Appendix A: Meeting Summaries

County Highway 61/Highway 41 Improvements Carver County

Figure 9

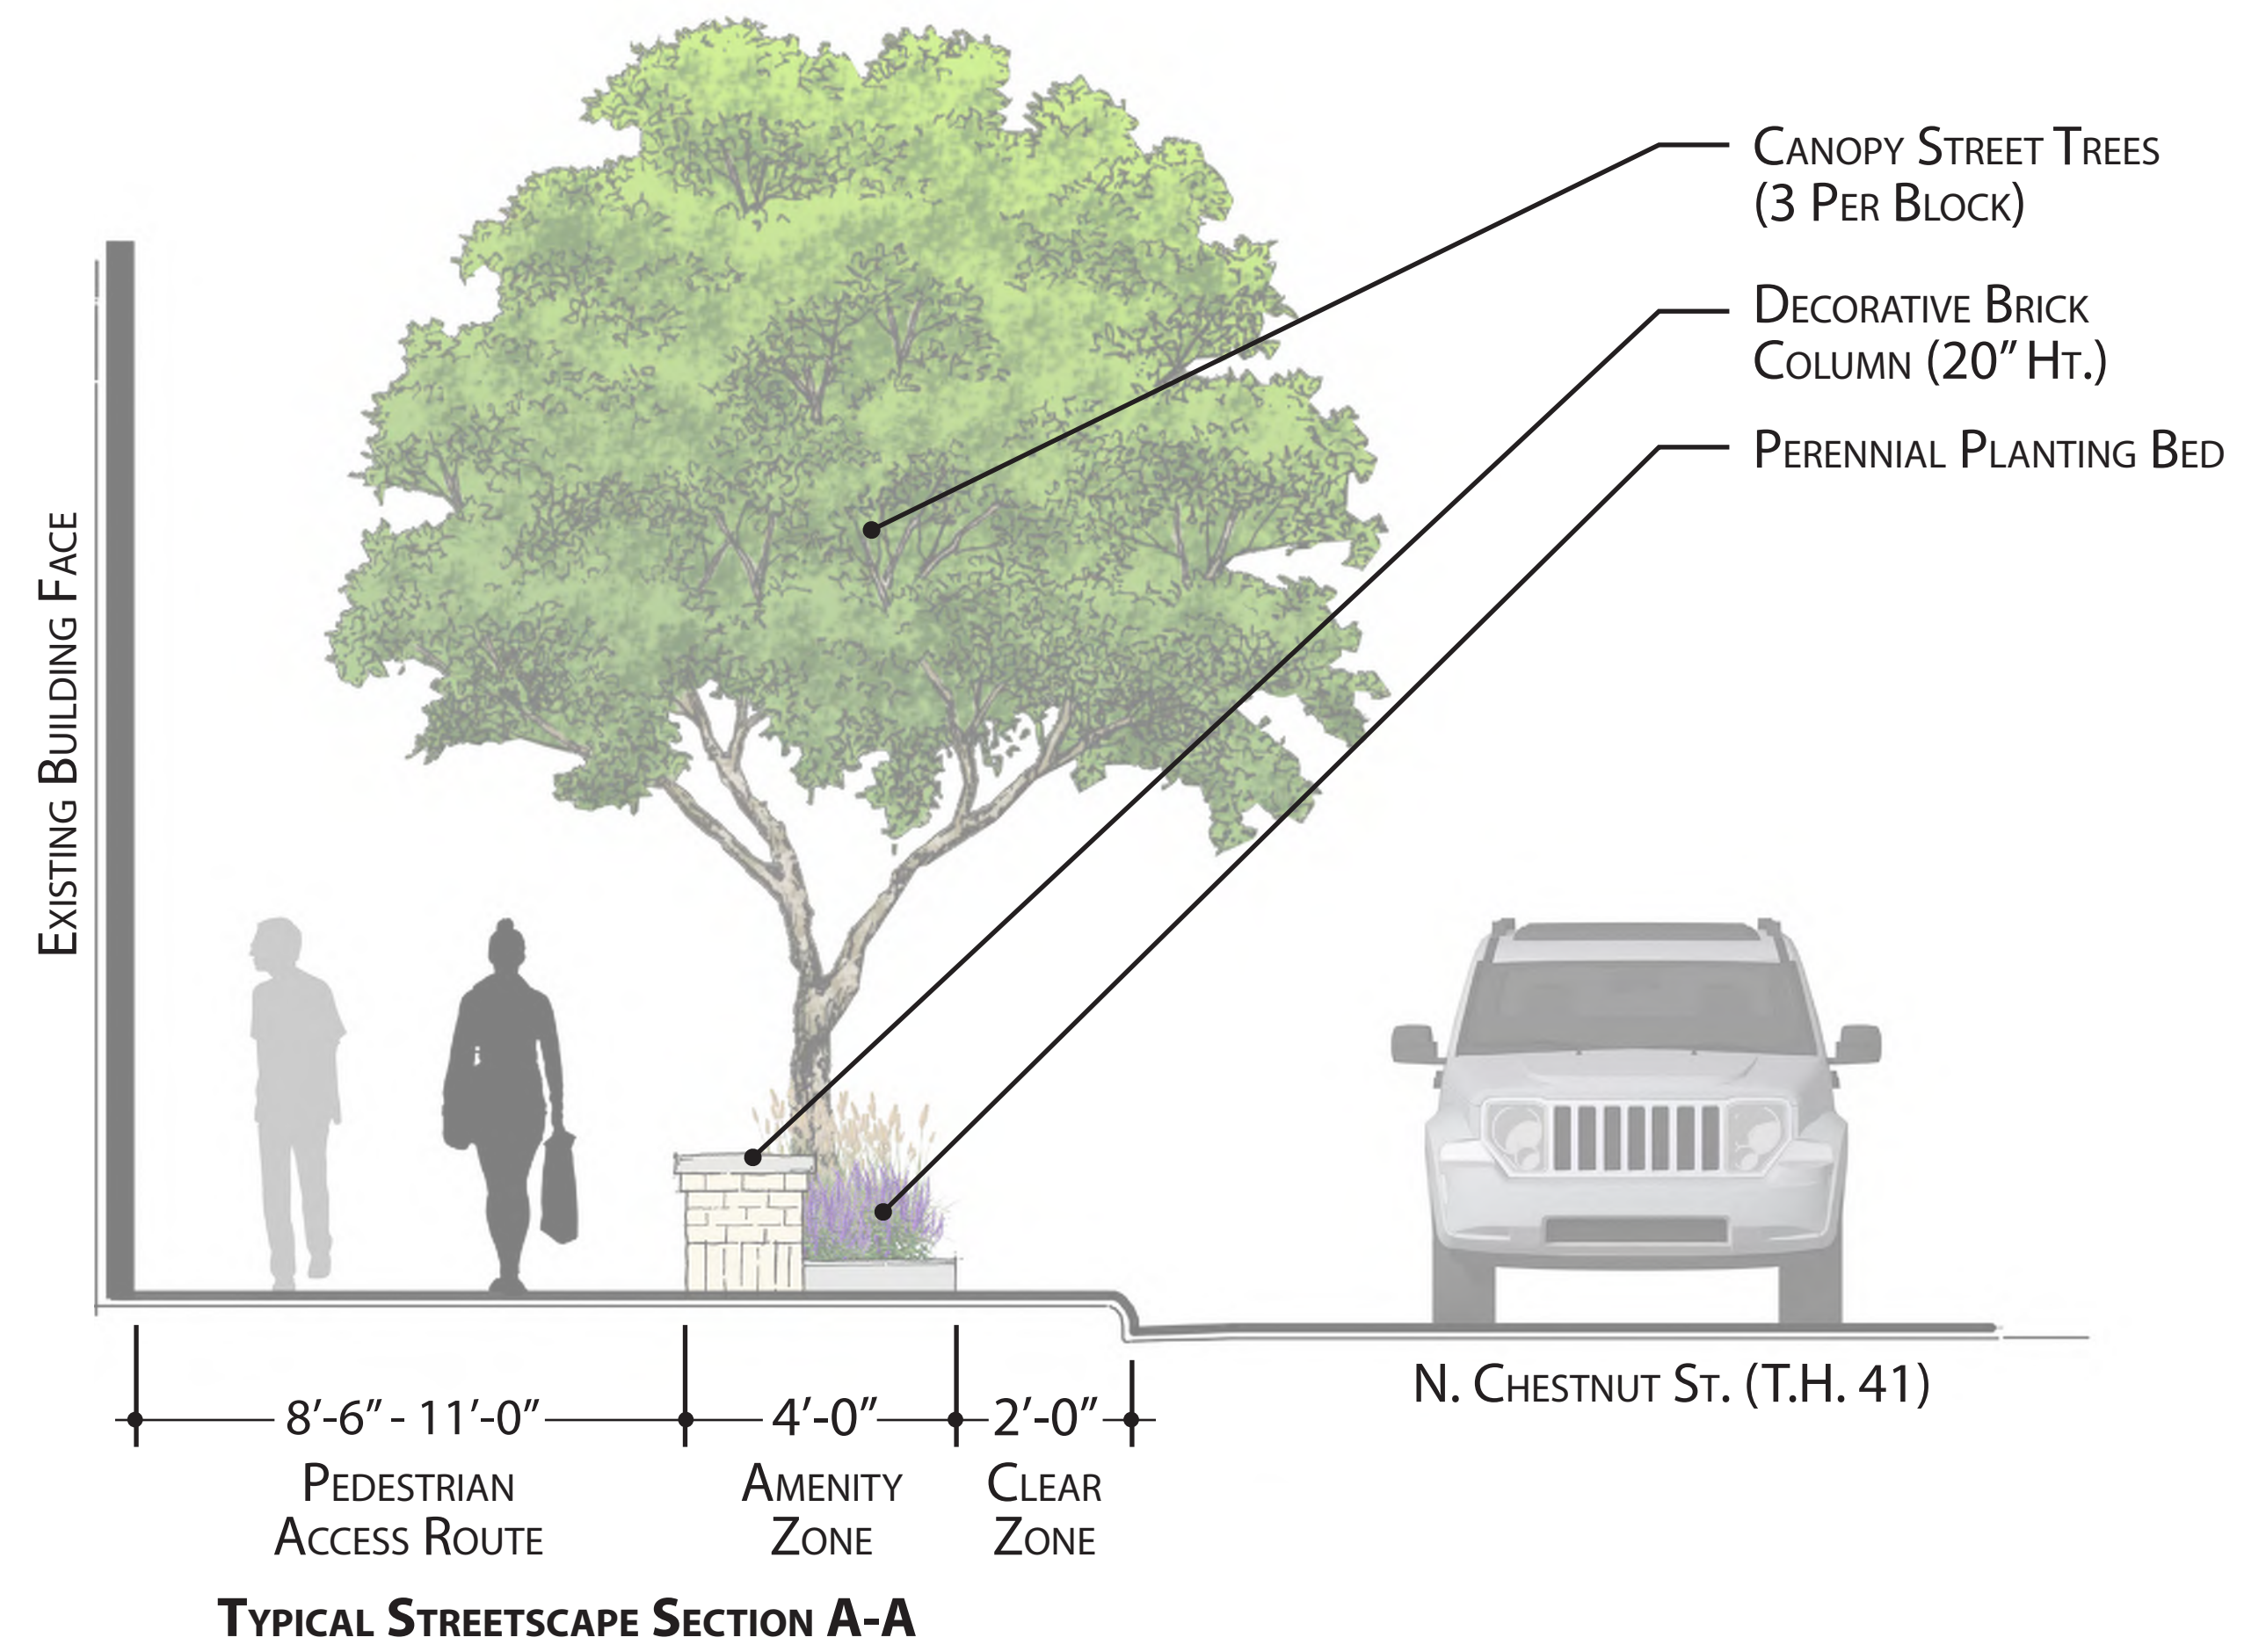
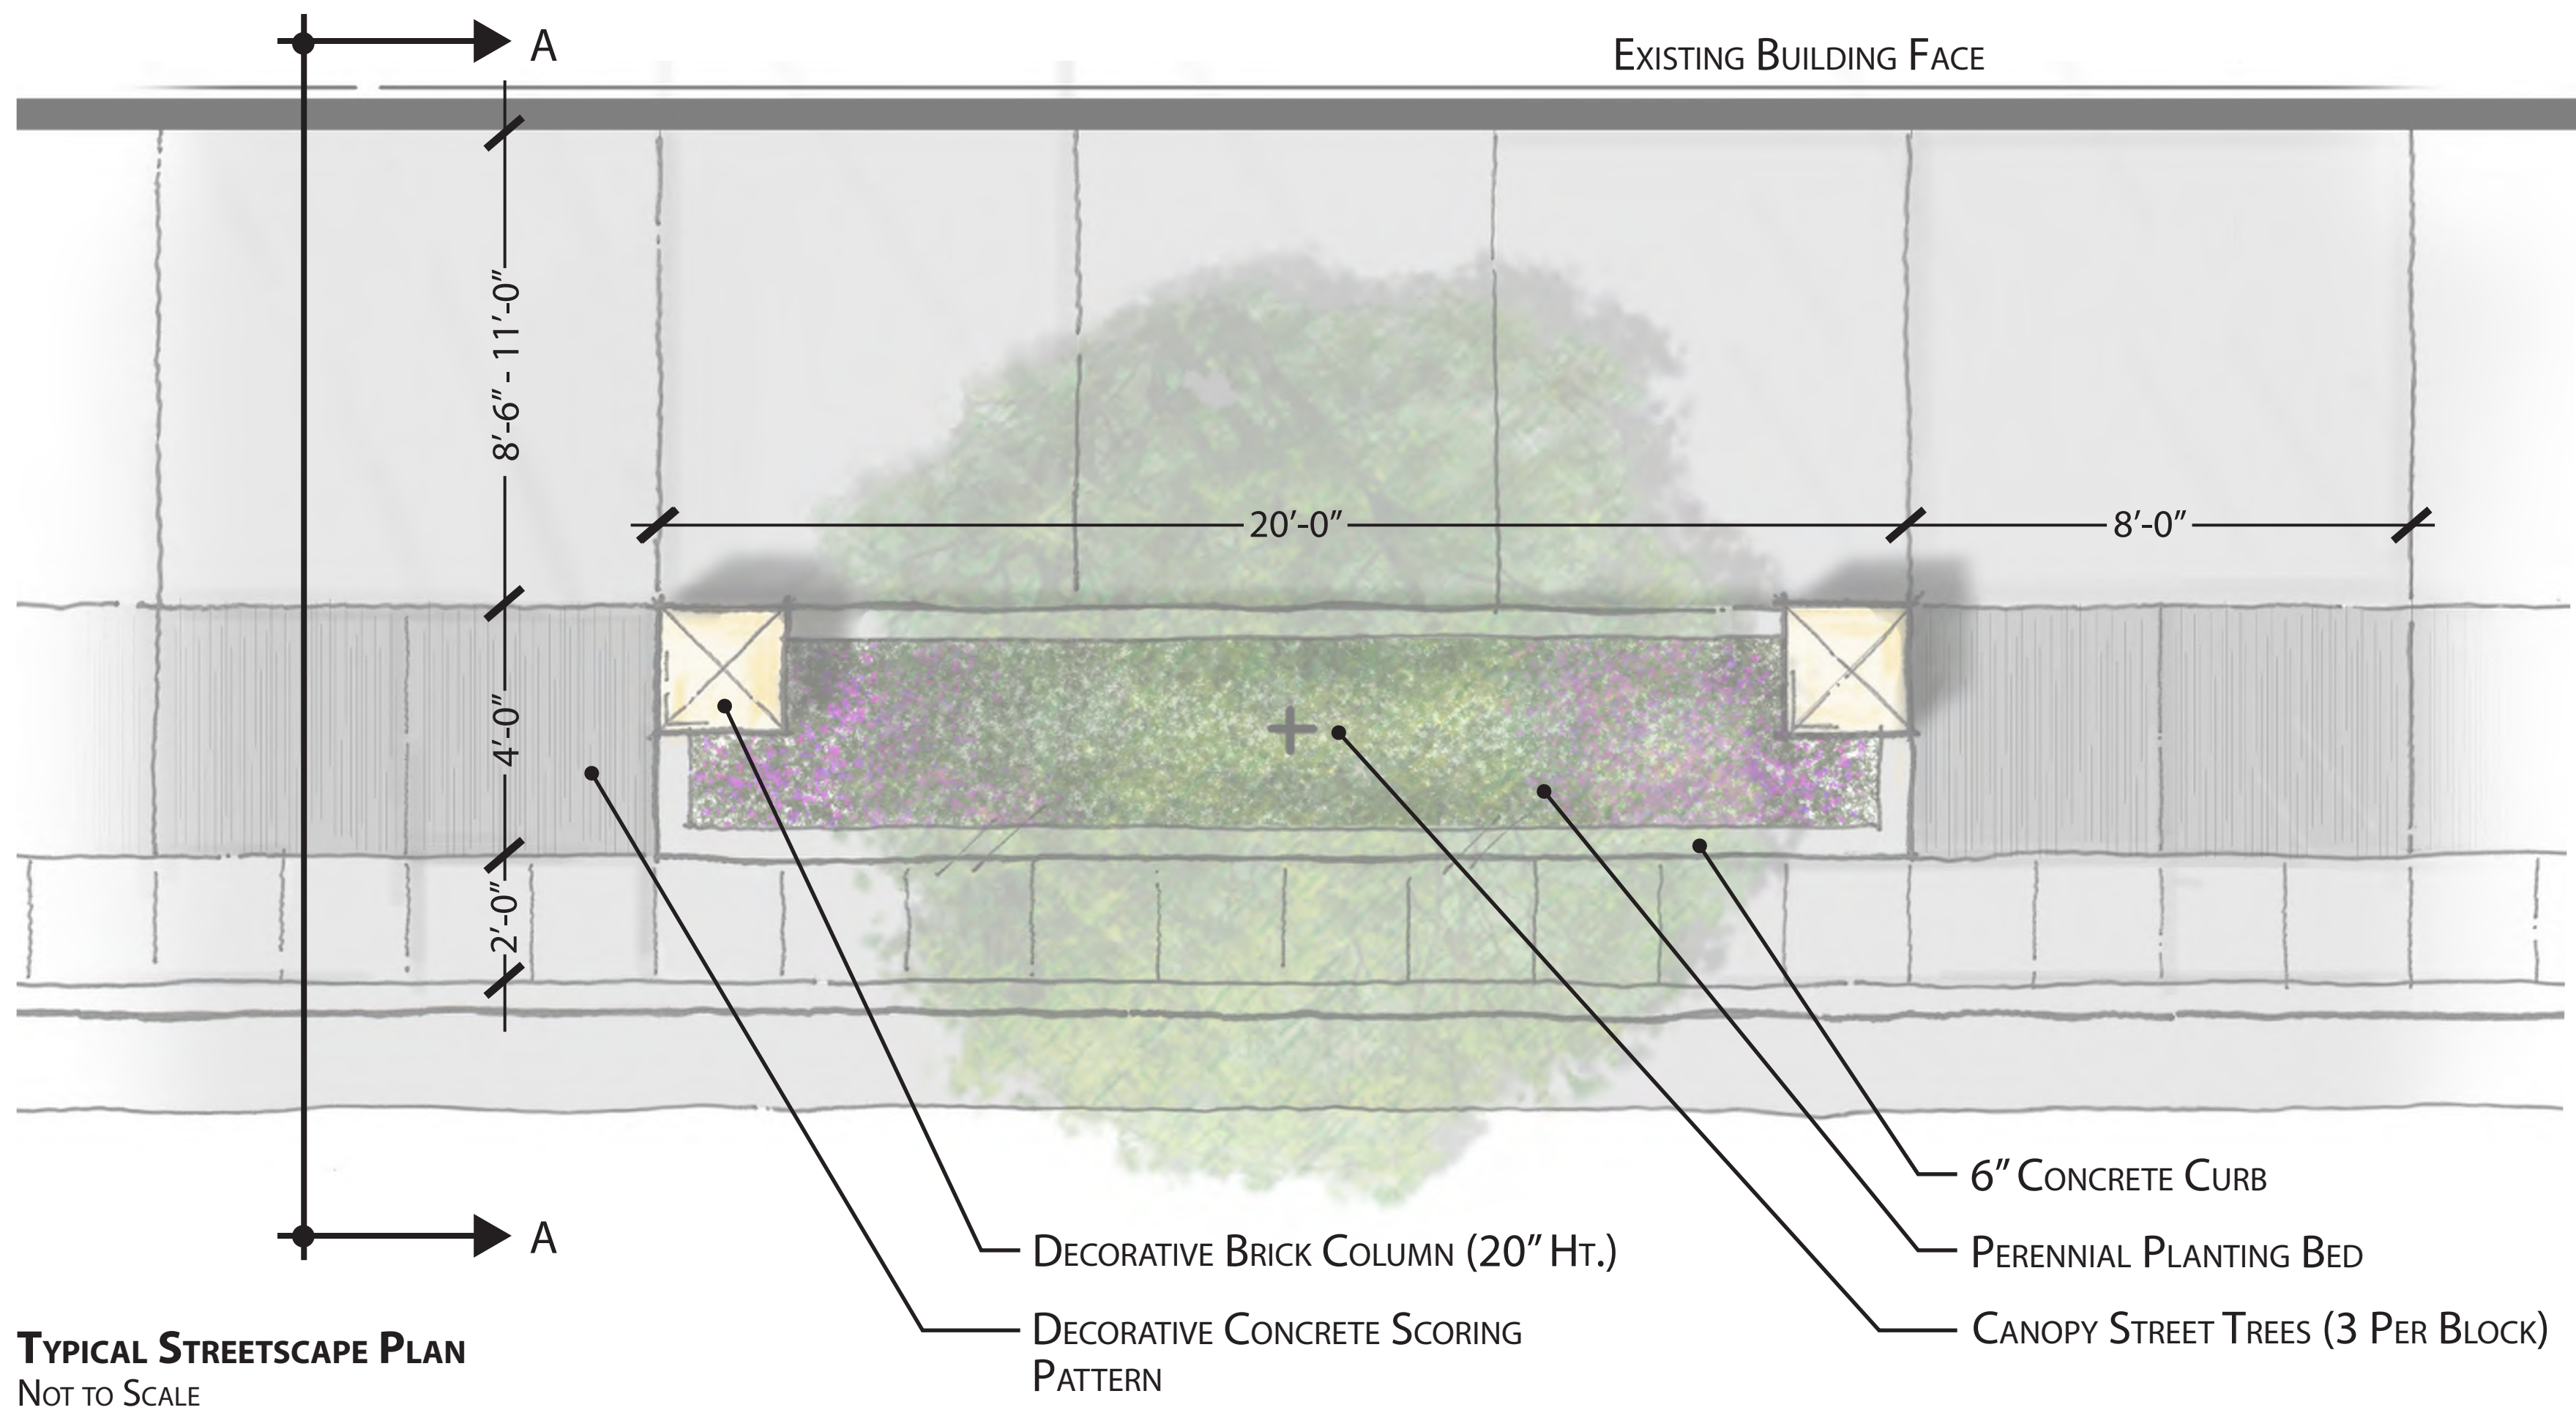
Figure 9 should be amended or supplemented with and edited figure 9 that shows how the tree/vegetated planters stormwater BMP's would work. This way, the intent of the groups' comments on this BMP can be carried forward. Applicable examples were sent to BMI. Examples shown at the 10/13/16 meeting are not applicable to the downtown area and seemingly may have misled some TAC members on what these features might look like.

Response: The graphics in Figure 9 are intended to be schematic representations of a potential tree trench/planter box layout. Also, they are landscape architectural renderings previously used as place holders for future landscape considerations. All of the preliminary BMPs discussed in the report shall endure rigorous final design considerations, construction sequencing and details and cost estimating and will incorporate all comments provided by the TAC (including the Capital Region Watershed design guidance, or similar). We do not anticipate final design considerations until future phases are planned.

Figure 5: East Chaska Area preliminary stormwater management exhibit. BMPs identified above are conceptual only. Sizes and locations of BMPs shall be further refined under future preliminary road way improvement and construction planning phases.

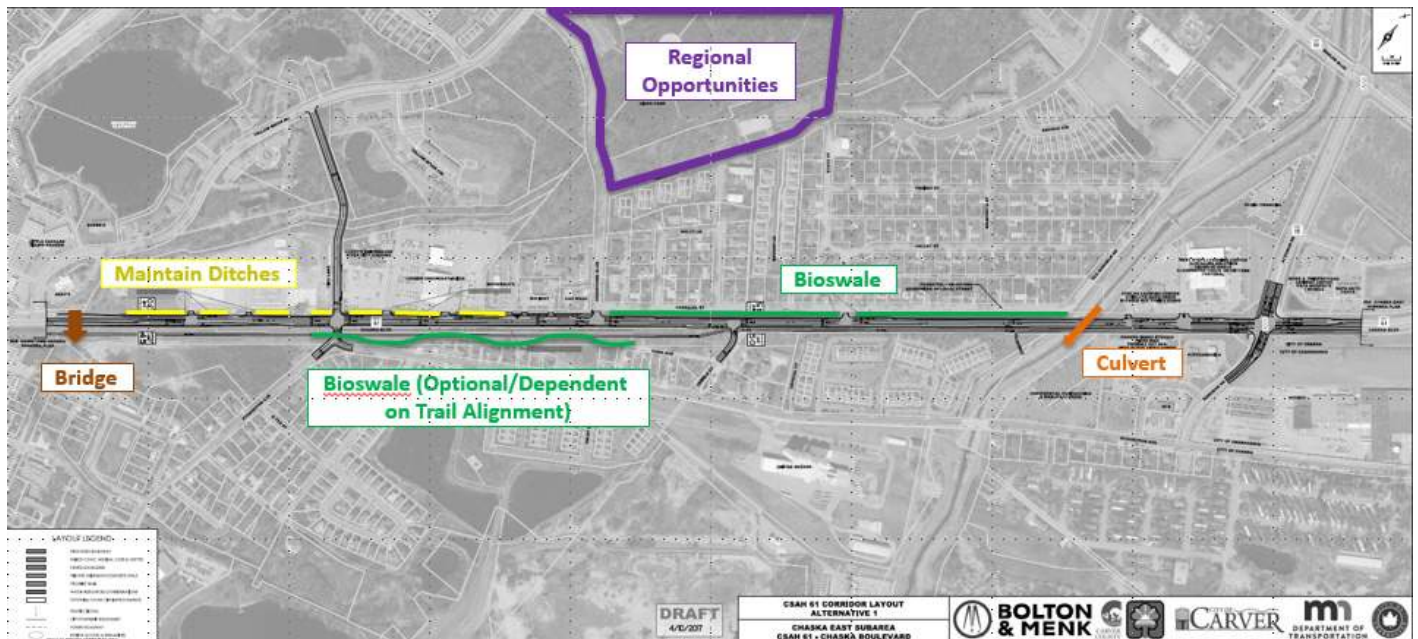
5. *Figure 5 – If possible, maybe show the bioswale on the north side of CSAH 61 as an option if the regional rail authority doesn’t want the bioswale on that property.*

Figure 6: Primary water resources and environmental features in the Eastern Project Area. BMPs identified above are conceptual only. Sizes and locations of BMPs shall be further refined under future preliminary road way improvement and construction planning phases.

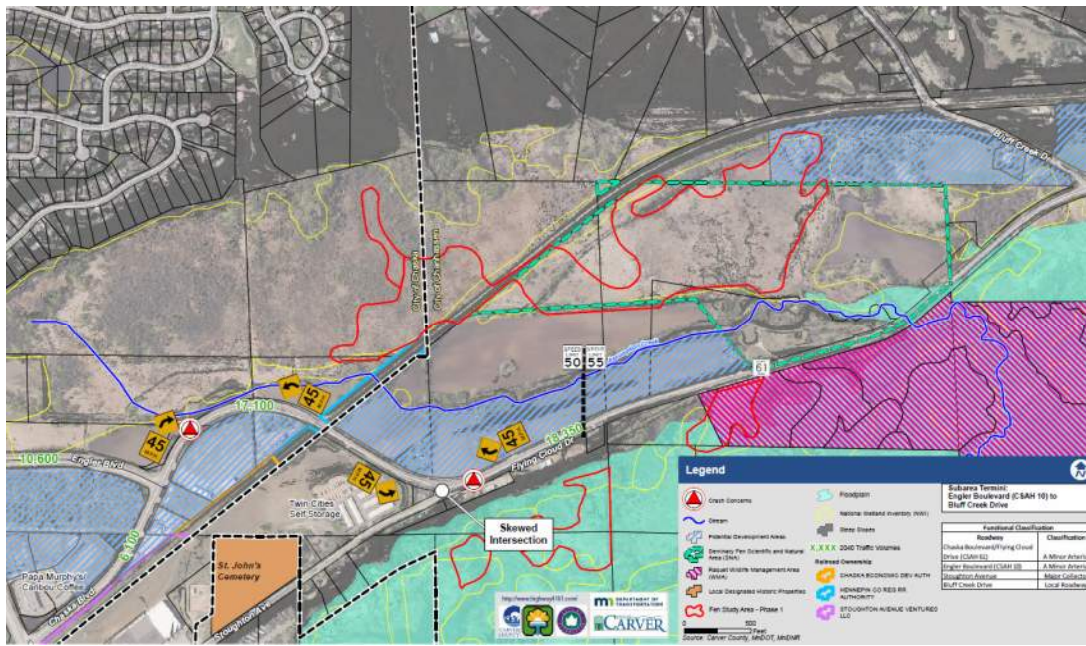
3. *In Figure 6 – The Trout Stream Restoration should maybe be labeled something different, as others will view restoration as something major. Maybe protection or something equivalent would be a better term to use, which would match the narrative.*
